MEC170x

Silicon Errata and Data Sheet Clarification

FIGURE 1: HIGH IBAT CURRENT DURING COIN CELL INSERTION

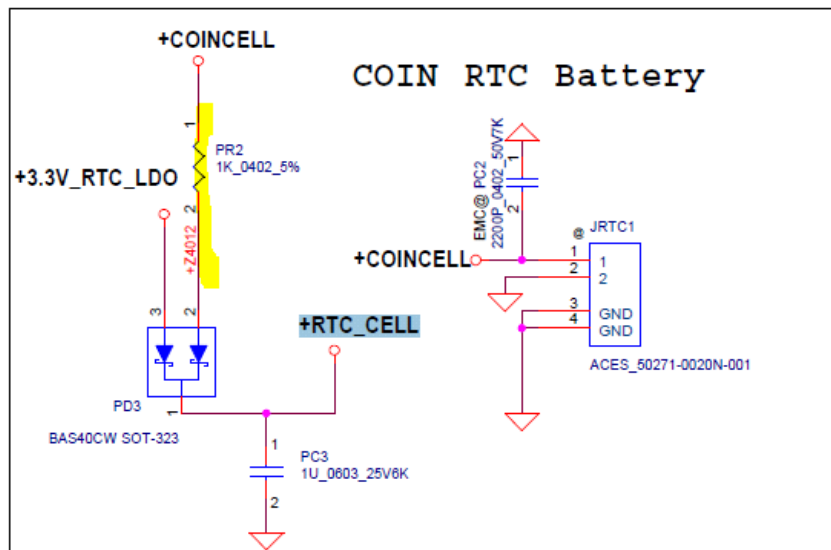
There could be a high I_{BAT} current on new coin cell insertion. During initial VBAT power rising, the VBAT circuit can enter a high current state causing a voltage drop across the 1K UL resistor. This affects all 128 and 144 pin packages. This issue is not present in the 169 pin packages.

- Under these conditions, the VBAT power on can stall in this high current state, with the VBAT on device pin between 0.7 and 1.2V.

Insert the coin cell and then apply VTR (i.e +3VALW). This enables VBAT low-power operation. A high I_{BAT} will not return on subsequent VTR power cycles.

Referring to the RTC Battery circuit shown in [Figure 1](#), applying VTR via the +3.3V_RTC_LDO signal, powers RTC_Cell (which is connected to VBAT of MEC170x) directly (without a series 1k resistor and hence no IR drop from the applied VTR), raising VBAT (RTC_Cell) to greater than 2.0 volts. This takes VBAT out of the “high current” region discussed above enabling normal VBAT low power operation.
